# Service Bulletin

Bulletin No.: 18-NA-239

**Subject: Squeak, Rubbing and/or Grinding Type Noise Heard From Steering Wheel When Turning**

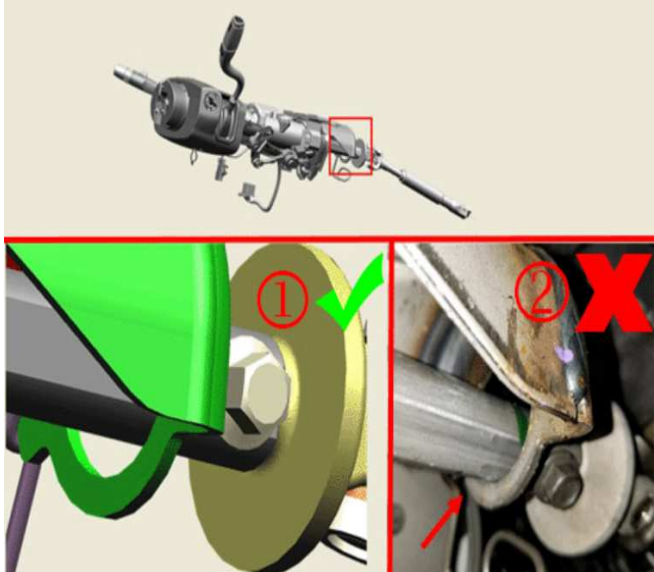
<p>Correction</p>	 <p>5107122</p> <p>Shown in the illustration above is an example of a good part making no contact with the bracket (1), and a example of a bad part making contact (2).</p> <p>Inspect the steering column for coming in contact with the bracket to verify that the noise is the result of rubbing between the steering column and the bracket. Install washers on the upper column mounting bracket locations following the procedure below.</p> <p><b>Important: DO NOT</b> replace the steering column for this condition.</p>
-------------------	--

5135065

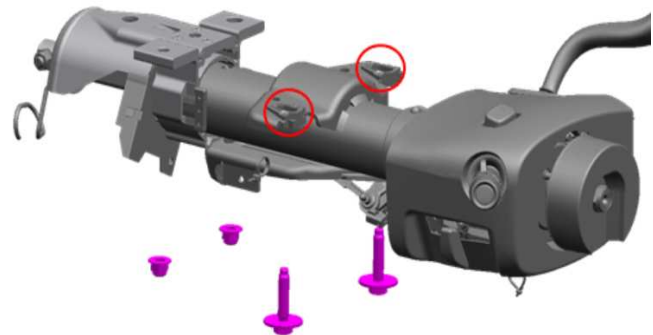
8. Install washers on the upper column mounting bracket, as shown in the illustration above.

**Tip:** An adhesive such as Kent strip caulk P10310, or equivalent, can be used to hold the shims in place during installation of the steering column.

5034403

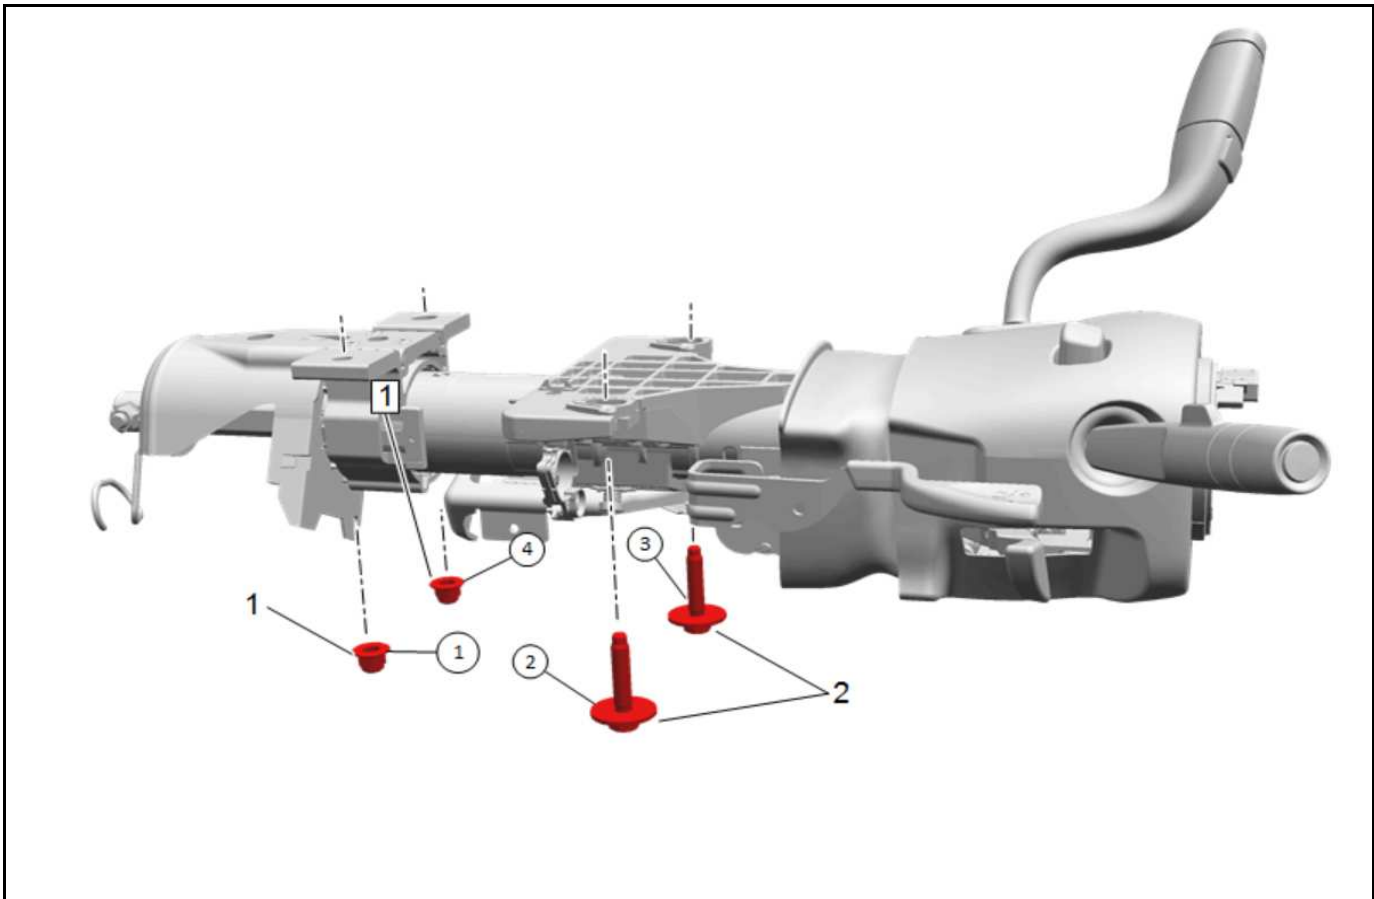
9. Tighten the steering column nuts (1) and bolts (2).

Tighten in sequence [2x] 27 N.m (20 lb ft)
